**TOWN OF CORTLANDT
PLANNING BOARD
PB 6-16**

MEMORANDUM

SUBJECT: PB 4-14 Application of Mongoose Inc. for the property of Mongoose Inc., Commercial Real Estate Asset Management Inc., and JPG Cortlandt Inc., for Preliminary Plat approval and Steep Slope, Wetland and Tree Removal permits for a 6 lot subdivision (5 building lots and 1 open space parcel) of a 128.8 acre parcel of property located on the south side of Maple Avenue and on the east side of Dickerson Road and Hilltop Drive as shown on a 5 page set of drawings entitled “Subdivision of Abee Rose Situate in the Town of Cortlandt, Westchester County, NY” prepared by Badey & Watson Surveying and Engineering PC, latest revision dated July 20, 2015.

**RE: PB 4-14: Application of Mongoose Inc.
Dickerson Road and Hilltop Drive**

A-201

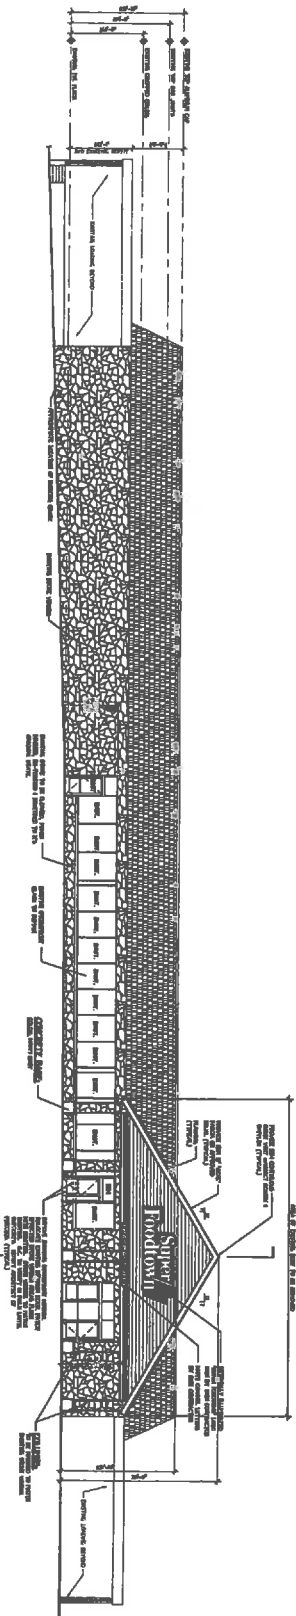
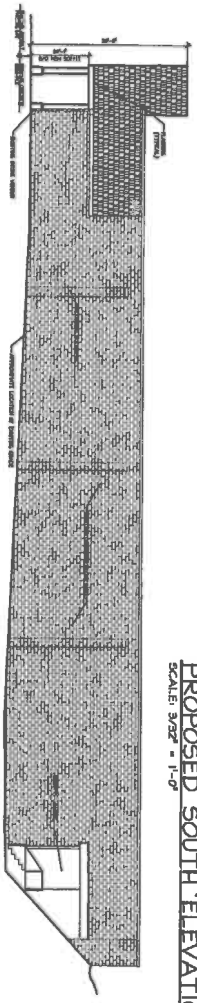
Please find attached renderings of the Foodtown front façade.

The owners wish to modify the store's roof to show only one peaked, gable end instead of the 5 peaks approved by your Board recently.

We are requesting the Planning Board's approval of to modify the original approval to construct only the improvements to the right side of the building, as shown.
